From: Chief Officer, Environment & Technical **To:** Chief Officer Planning & Regulatory
Our Ref: PR/DC/P/2019/0792 **Your Ref:** SEH/P/2019/0792
Date: 24th April 2020

Location: O. S Grid Ref: 350 504 Community Centre, Eaton Drive, Wrexham.

Development: Demolition of existing community centre, erection of new apartment block comprising 10 no. two bed apartments and 6 no. 1 bed apartments.

I refer to your consultation / email dated 24/04/2020 including layout plans (Drg. Nos. SK10 Rev A and SK11 Rev A) in respect of the above.

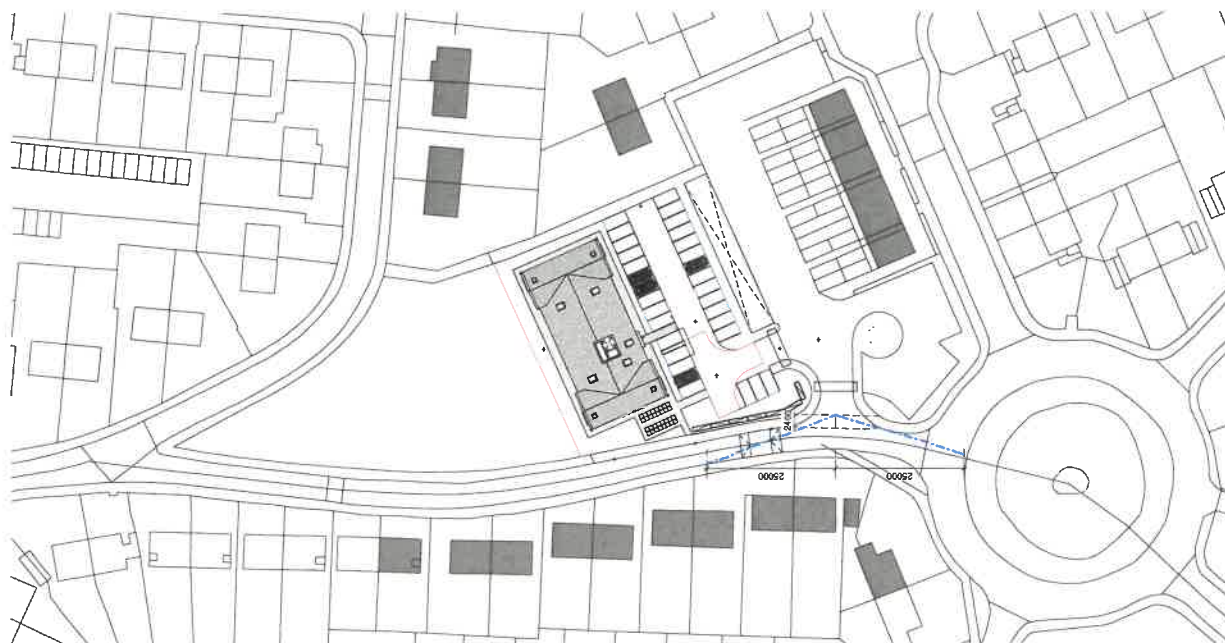
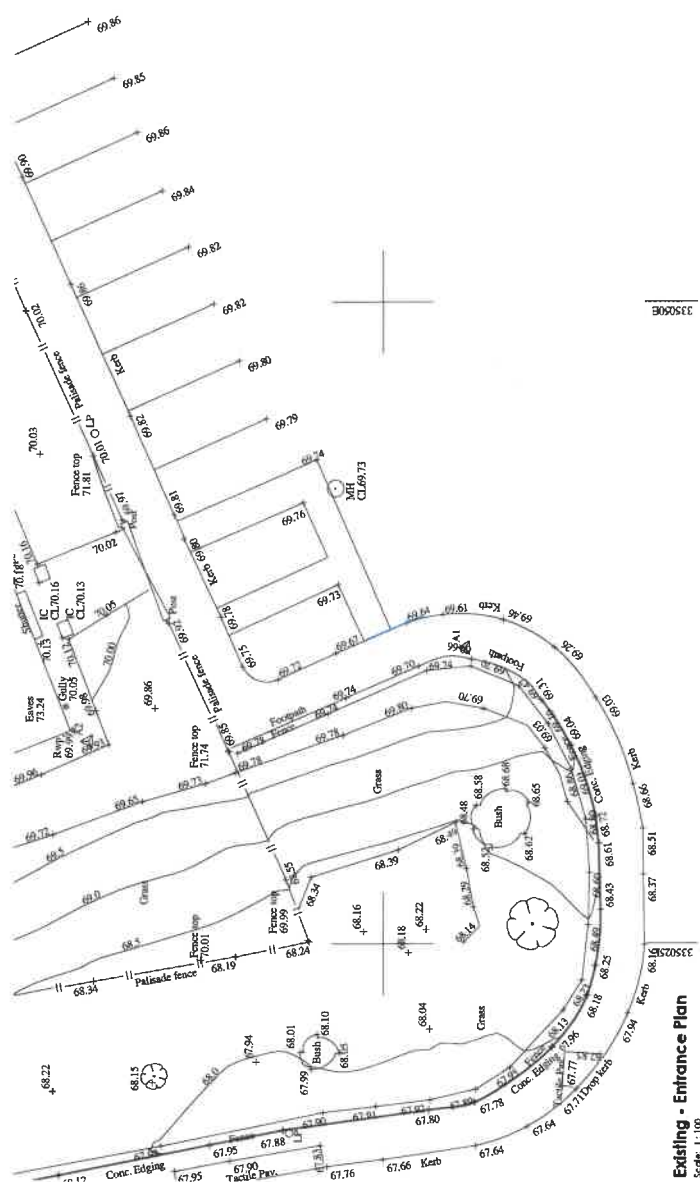
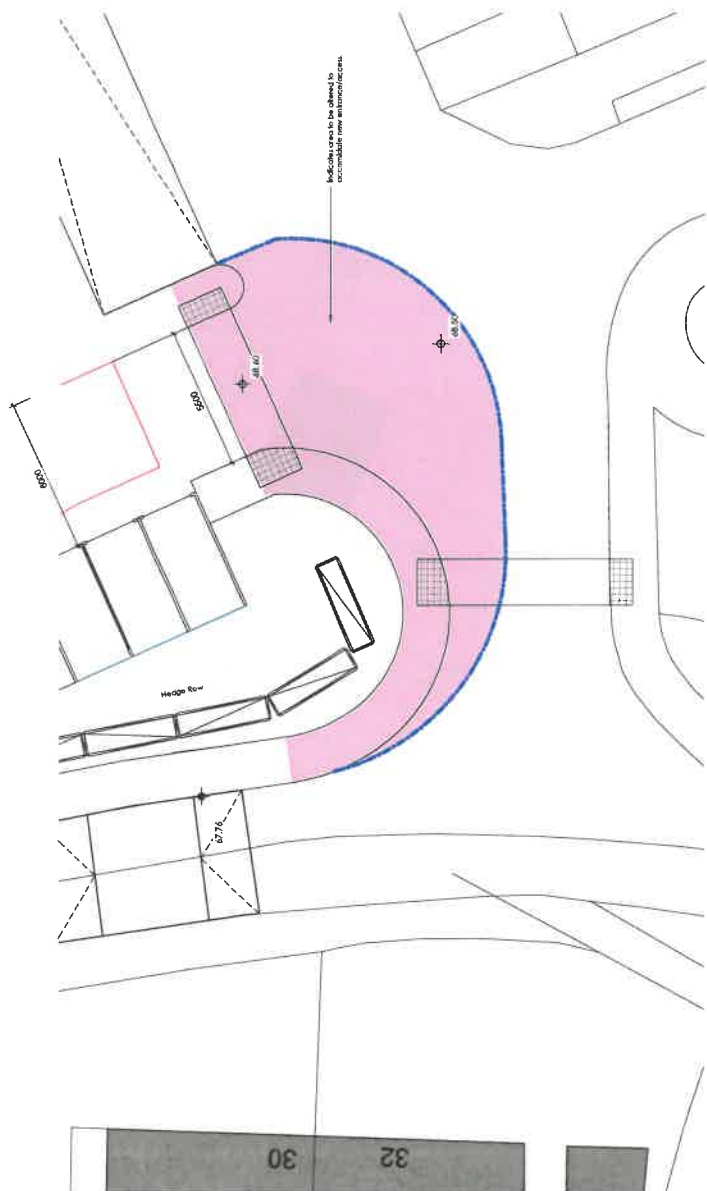
There are existing sections of adopted highway passing through the development site. These sections of adopted highway / footway will need to be stopped up by the applicant prior to the commencement of any development.

I understand that the applicant will be required to apply for consent to the Welsh Government to stop up this section of adopted highway under the Town and Country Planning Act 1990 – Section 247. I would recommend that this is included as a pre-commencement condition should the proposed development be supported.
